CCEA MOBA

1 / Je 3D model možné poskytnout i v jiném formátu než max?

1 / Can you provide the 3D model in other format than max?

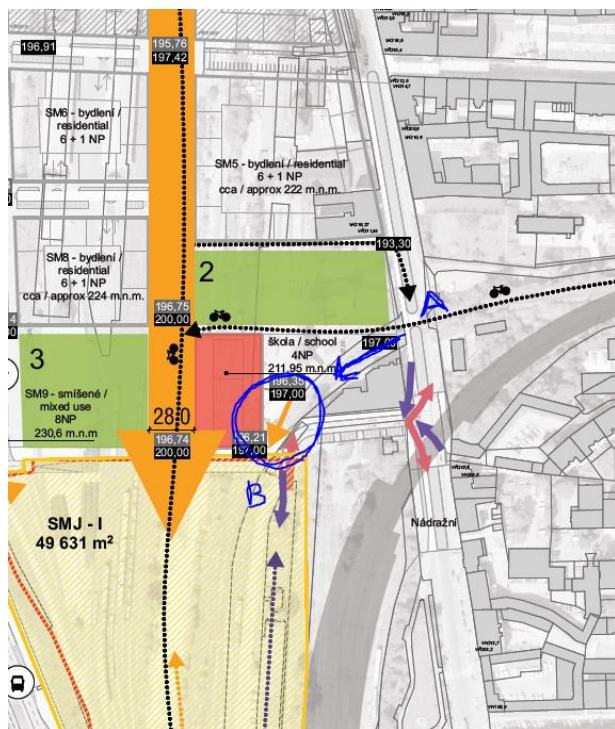
19 / Co znamená oranžová šipka? Viz přiložený obrázek.

19 / there is an orange arrow indicating pedestrian entry to the SMC area on the south east edge of the site. Does it mean there will be a public passage through the site following the line of the railway tracks - leading people from the viaduct to the end of the arrow (from A to B)? Please see the attached image.

Oranžová šipka indikuje tok chodců do Smíchov City Jih; tedy chodník podél ulice vedoucí ke škole a vstup do jižní části území.

The orange arrow indicates a pedestrian flow to the South of the Smíchov City, meaning a sidewalk/pavement along the street leading towards the school and access to the southern part of the whole area.

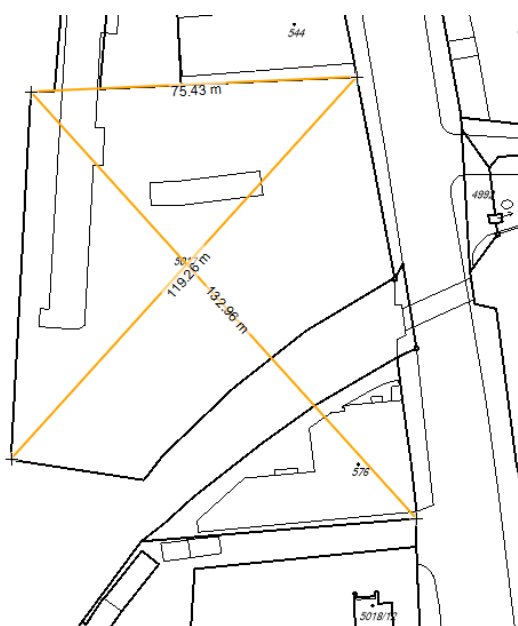
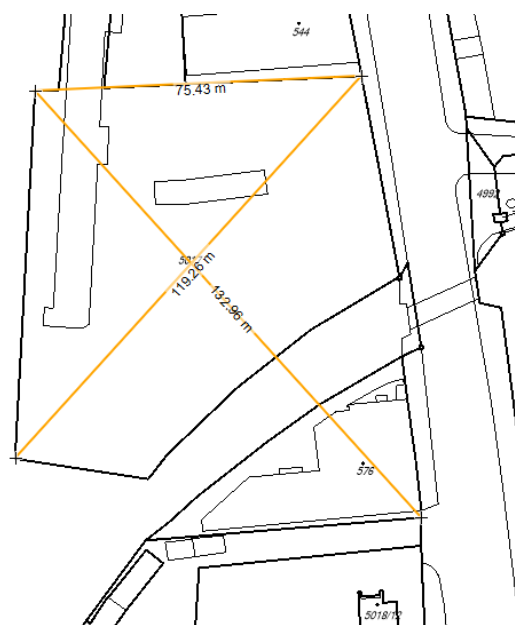
22 / Mohli byste zobrazit některé rozměry v katastrální mapě, aby bylo možné ověřit správné měřítko importu dwg souboru?

22 / Please could you show on the cadstral map a figured dimension, ie a length of the site boundary, to ensure that the cadastral dwg file is imported at the correct scale.

Níže zobrazeny jsou rozměry parcely č. 5017. Skutečné rozměry lze také ověřit např. na www.nahlizenidok.cuzk.cz

We are providing the cadastral map with the dimensions of the plot no. 5017 next to the competition site. The real dimensions can be easily checked on i.e. www.nahlizenidok.cuzk.cz
